Re: Petition No. 1291  
Towantic Line Upgrade Project  
Shift of Location for Structure #830

Shift of Location for Structure #830

**TOWANTIC 1710/1730  
LINE UPGRADES PROJECT**  
FEBRUARY 09, 2017  
REVISED: JANUARY 09, 2018  
CITY OF MILFORD (NEW HAVEN COUNTY) AND TOWNS  
OF STRATFORD AND TRUMBULL (FAIRFIELD COUNTY), CONNECTICUT  
PAGE 14 OF 16  
MUNICIPALITY: STRATFORD, TRUMBULL

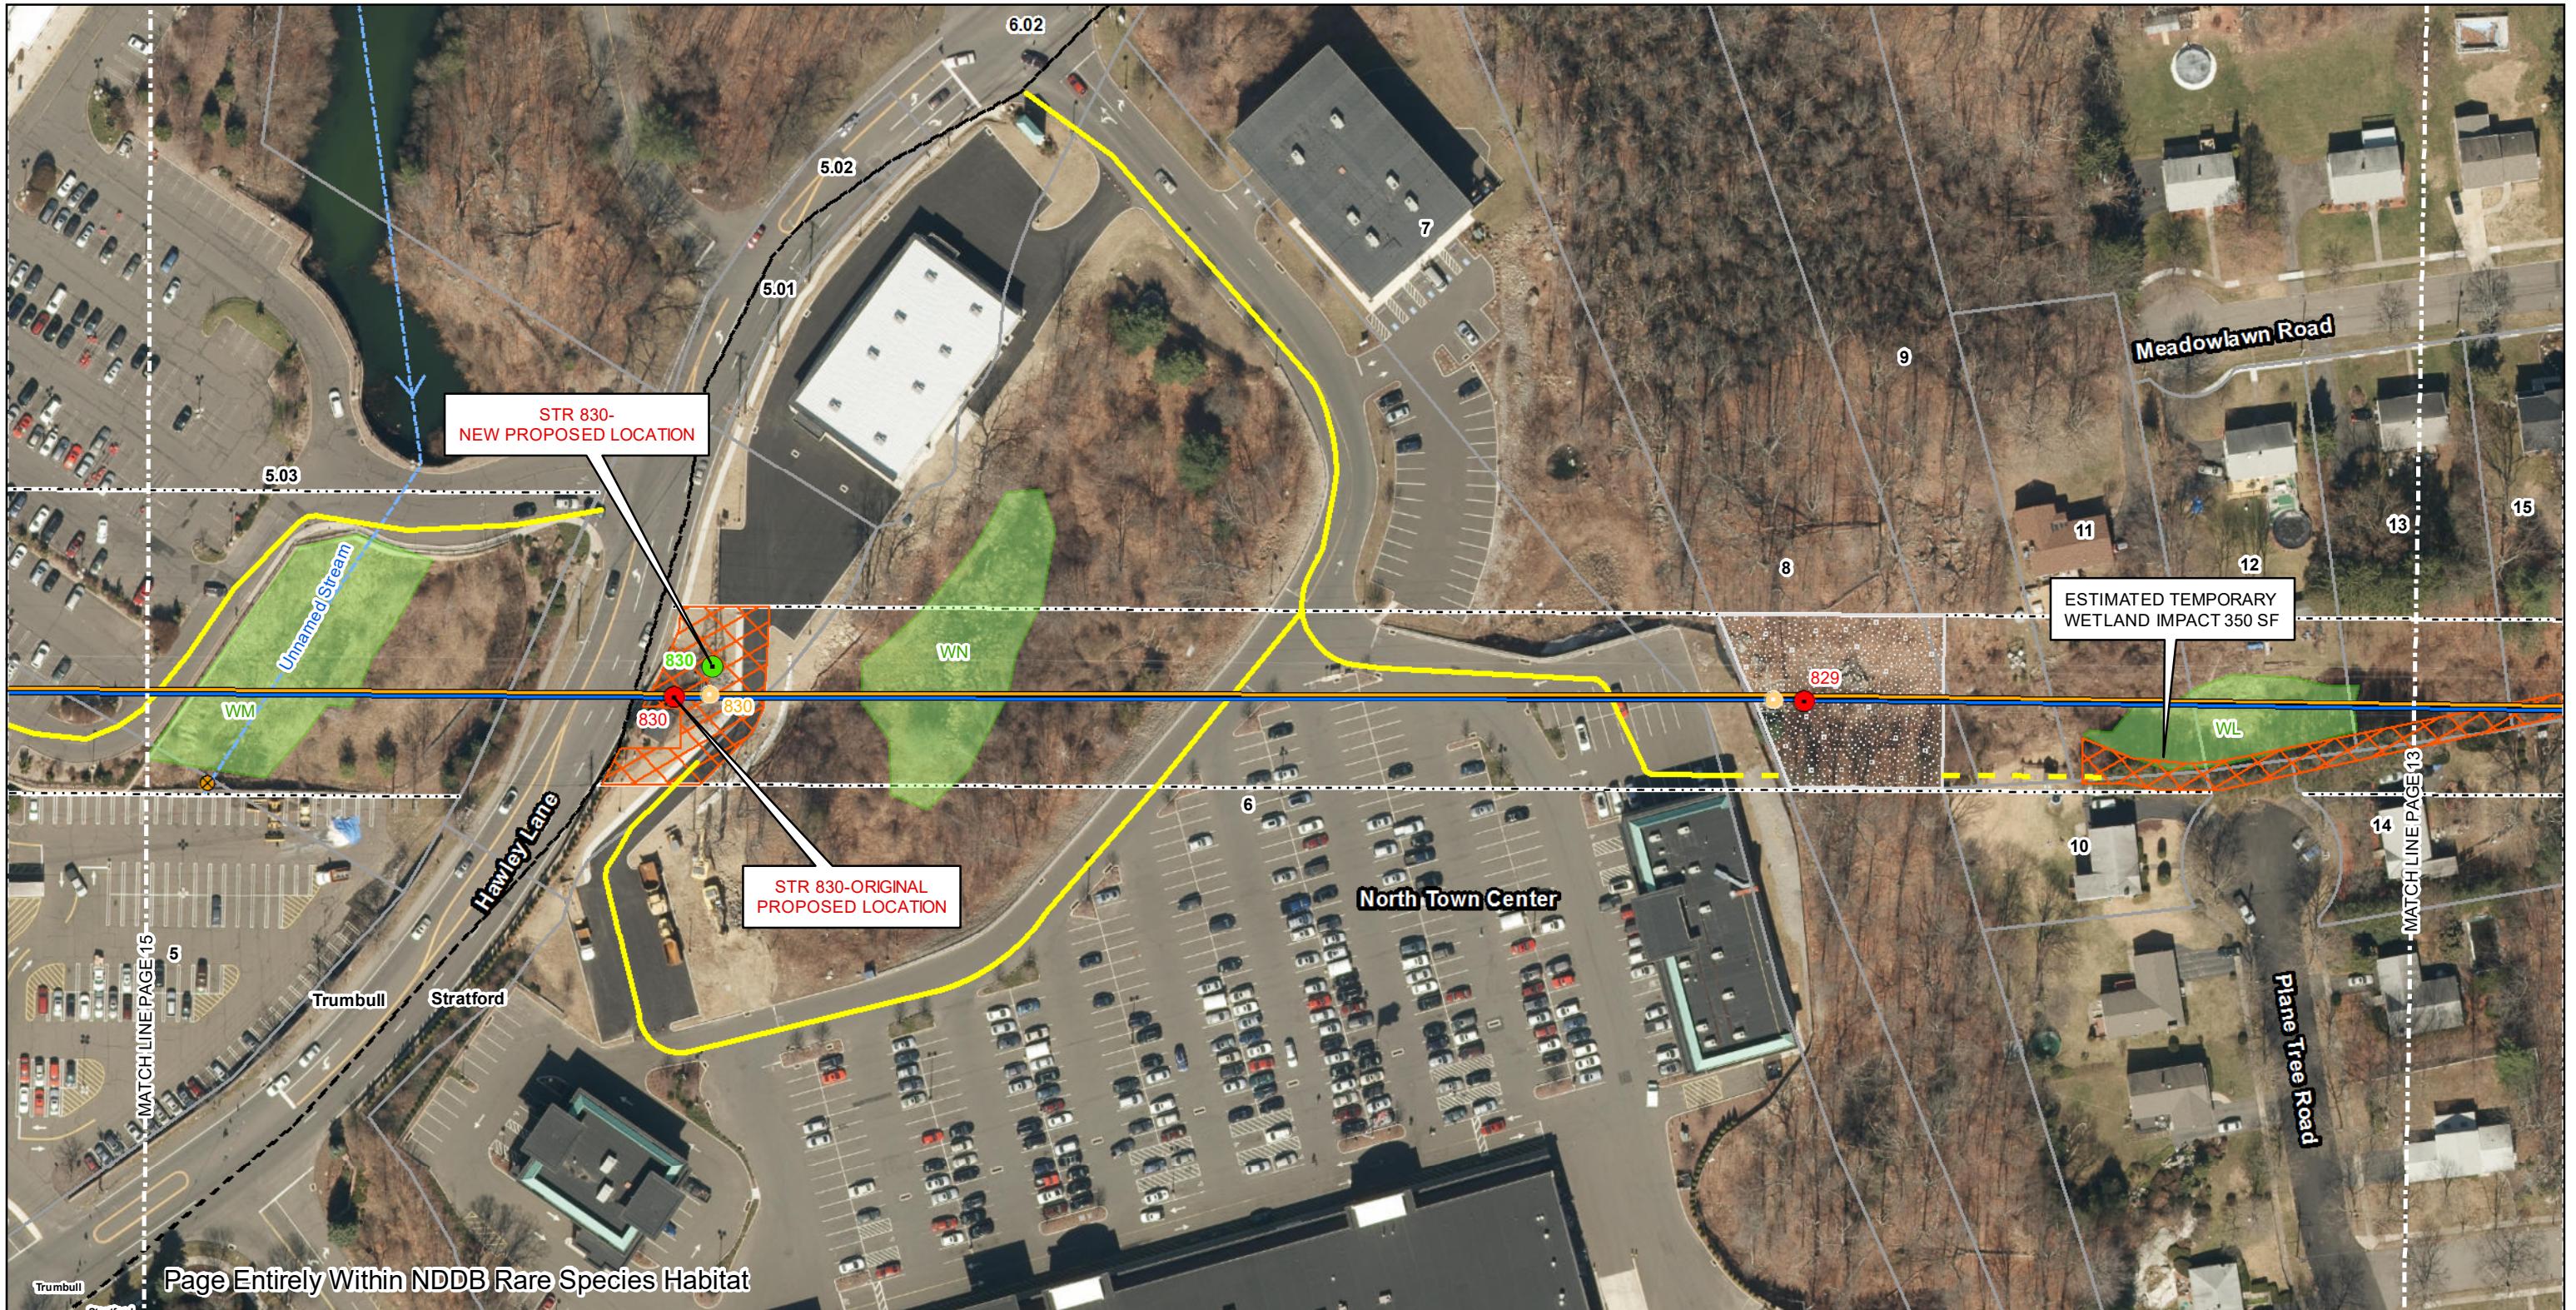
The location of this requested change is at Structure #830 which is situated on the east side of Hawley Lane adjacent to the North Town Center shopping mall in the Town of Stratford and is shown on the attached revised copy of Page 14 of 16 of the mapsheets submitted with the subject Petition (see Attachment A).

Eversource is requesting to shift the location of Structure 830 twenty-nine (29) feet to the northeast in order to reduce significant impacts to traffic on Hawley Lane(lane closures during construction) and to better accommodate construction sequencing for the relocation of Sprint’s cellular facilities that are currently in-service on this structure. The original structure location would have required closures of two of the three northbound lanes of Hawley Lane in order to accommodate all construction activities, which would have included the work pad installation, drilling, foundation and structure installation. In addition, the proposed structure shift allows the Project to keep the existing cellular facilities in-service while concurrently installing the new structure and new cellular equipment allowing for a shorter outage time for Sprint. Otherwise, since the original location of this proposed structure is so close to the existing ice-bridge which covers and protects Sprint’s cables coming from the existing structure to their equipment on the ground, the ice bridge and cables would have to be removed and Sprint’s cellular

facilities would have to be taken out of service during the installation of the proposed structure in its original location.
